**P21/3907 - FOUR GROUPED DWELLINGS – LOT 31 (NO. 161) LEACH HIGHWAY,
WILLAGEE WA 6156 (REC) (ATTACHMENT)**

Ward : Palmyra – Melville - Willagee
 Category : Operational
 Application Number : DA-2020-673
 Property : Lot 31 (No. 161) Leach Highway, Willagee WA 6156
 Proposal : Four Grouped Dwellings
 Applicant : Eric Soh, Architectural Studio 63
 Owner : Jason Fook Ngian Wong & Li Lu Khoo
 Disclosure of any Interest : No Officer involved in the preparation of this report has a declarable interest in this matter.
 Responsible Officer : Peter Prendergast
 Manager Statutory Planning
 Previous Items : Not Applicable

Figures 2a and 2b: First Floor Plan (left) and Second Floor Plan (right) overlay of the subject site and the neighbouring property. The measurement highlighted in red denotes the setback of the wall from the neighbouring western lot boundary.

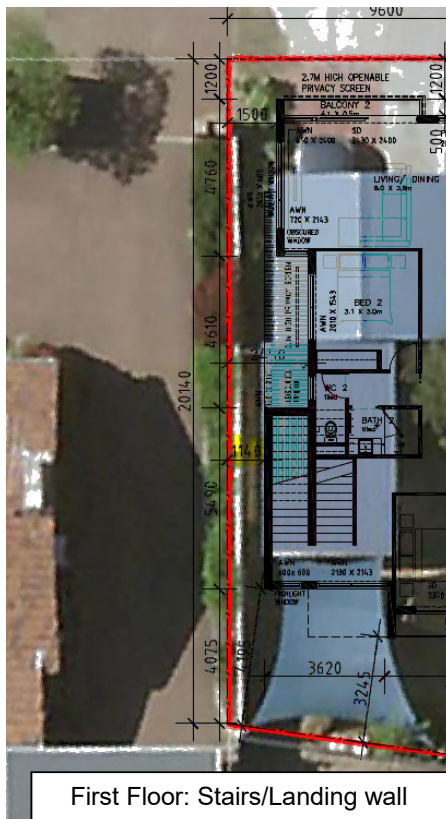
As detailed in the table above two sections of the western facing wall of unit four do not meet the deemed to comply provisions of the R-Codes and therefore require a performance assessment. The setbacks are considered to meet the Design Principles of the R-Codes for the following reasons:

- Both the first floor and second floor walls are well articulated through the use of varying materials, alternating wall heights, varied setbacks and window openings. This articulation ensures the walls will not add excess building bulk to the adjoining western property;
- The orientation of the wall will ensure that access to direct sunlight and ventilation to the adjoining western property will not be restricted;
- The wall is located next to the driveway area of the adjoining site. This serves to mitigate any potential bulk impact on the actual adjoining dwelling which is consequently set further away from the lot boundary.; and
- There are no major openings along this section of wall, ensuring the development does not pose any overlooking concerns for the adjoining owners/occupiers.
